1.0 APPLICATION SUMMARY

Applicant: Bryan Sykes, Meridian Partners Law
 FLU Category: NMU-4
 Service Area: City of Tampa
 Site Acreage: 61.88 +/-
 Community Plan Area: None
 Overlay: None

Current Request: To modify proposed access points to the project and proposed project circulation and create pedestrian and golf cart access at the northern property boundary. Add a third development option of a 55+/Age-Restricted community, with 111 Single-Family detached Units.

2.4 Proposed Site Plan (partial provided below for size and orientation purposes. See Section 8.2 for full site plan)

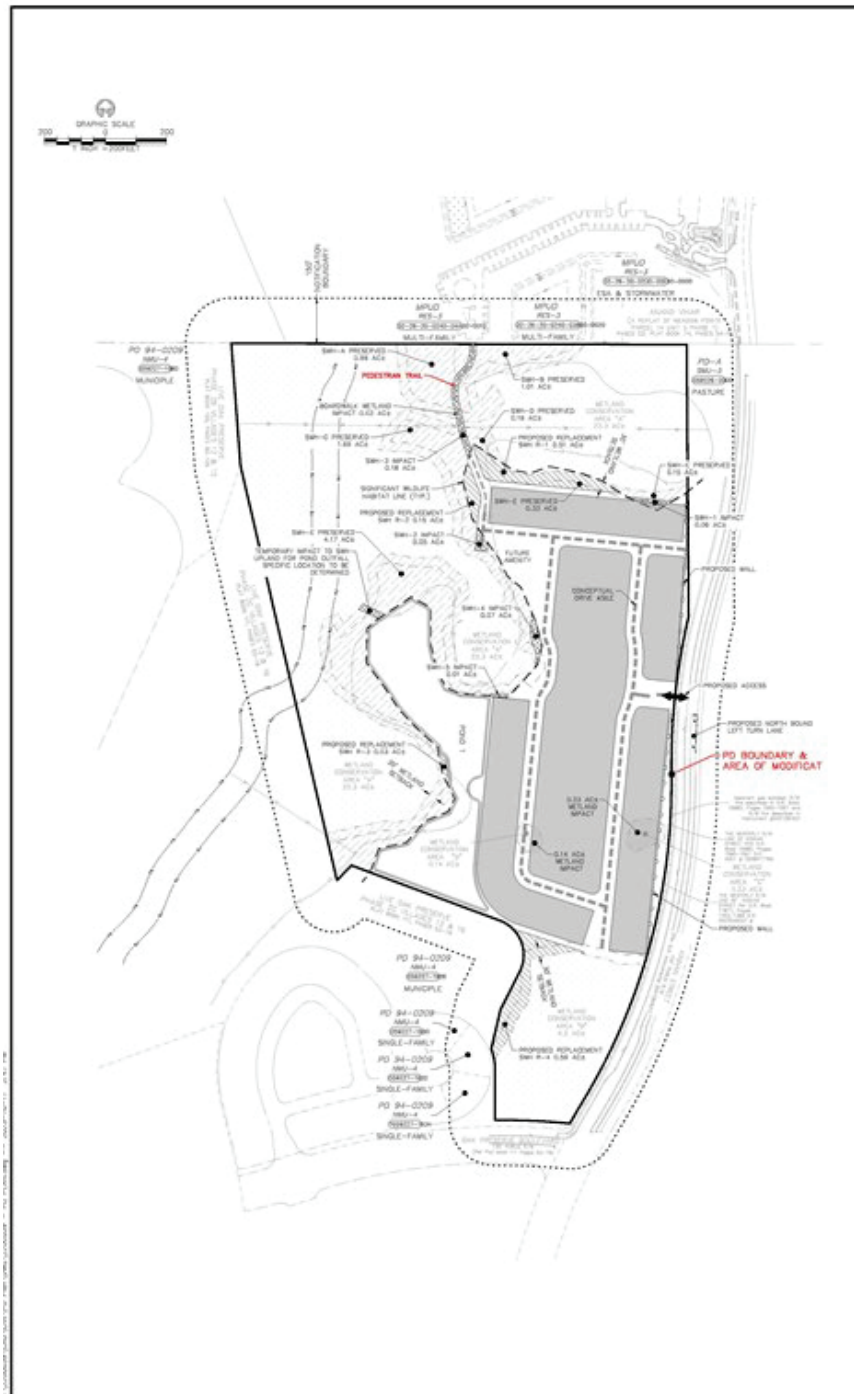
- Change the “Pedestrian Trail” on the site plan to read “Pedestrian and Golf Cart Trail”.

Development option 3 also includes a pedestrian and golfcart trail to the north to connect to an existing similar development to the north. The connection must be built according to Hillsborough County standards and be ADA accessible.

1. Change "Pedestrian Trail" on the site plan to read Pedestrian Trail and Golf Cart Trail.
2. A note placed on the face of the plan shall indicate that this project is deed-restricted.
3. Revise the site data table for development option Three to include the Minimum Porch Setback of 5 feet, Minimum Front Setback for Corner Lots (with front loading garage) 15 feet, and Minimum Front (with front loading garage) 20 feet.

8.2 Proposed Site Plan (Full)

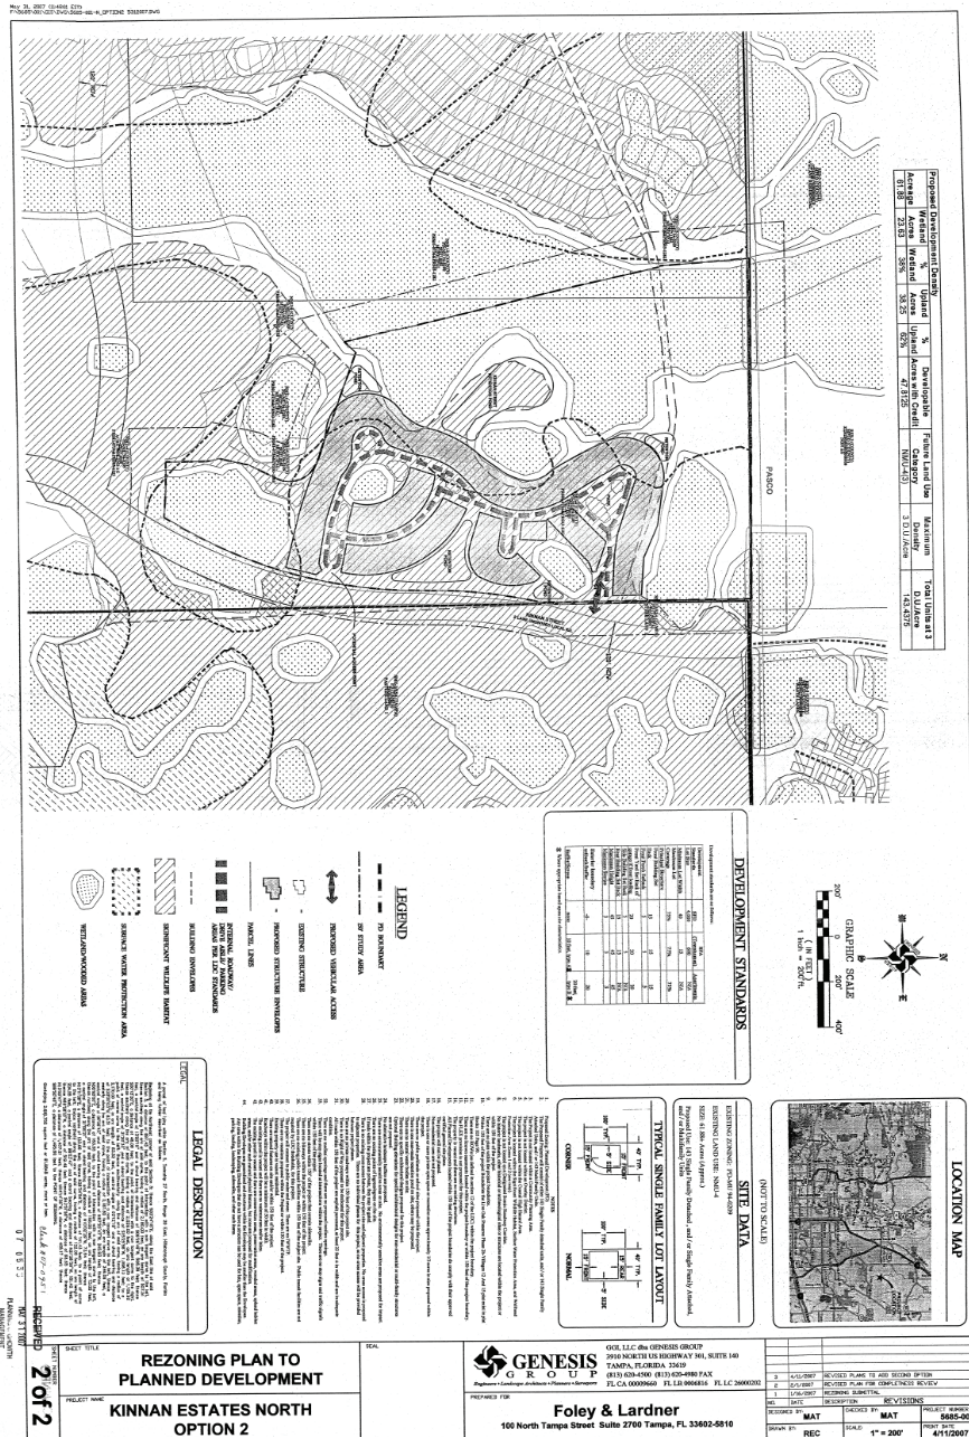
- The site plan depicts wetland impacts that were authorized by the Executive Director of the EPC on September 8, 2023. The wetland impacts are indicated for internal roadway and lots.

- The Hillsborough County Land Development Code (LDC) defines wetlands and other surface waters as Environmentally Sensitive Areas. Pursuant to the LDC, wetlands and other surface waters are further defined as Conservation Areas or Preservation Areas and these areas must be designated as such on all development plans and plats. A minimum setback must be maintained around the Conservation/Preservation Area and the setback line must also be shown on all future plan submittals.
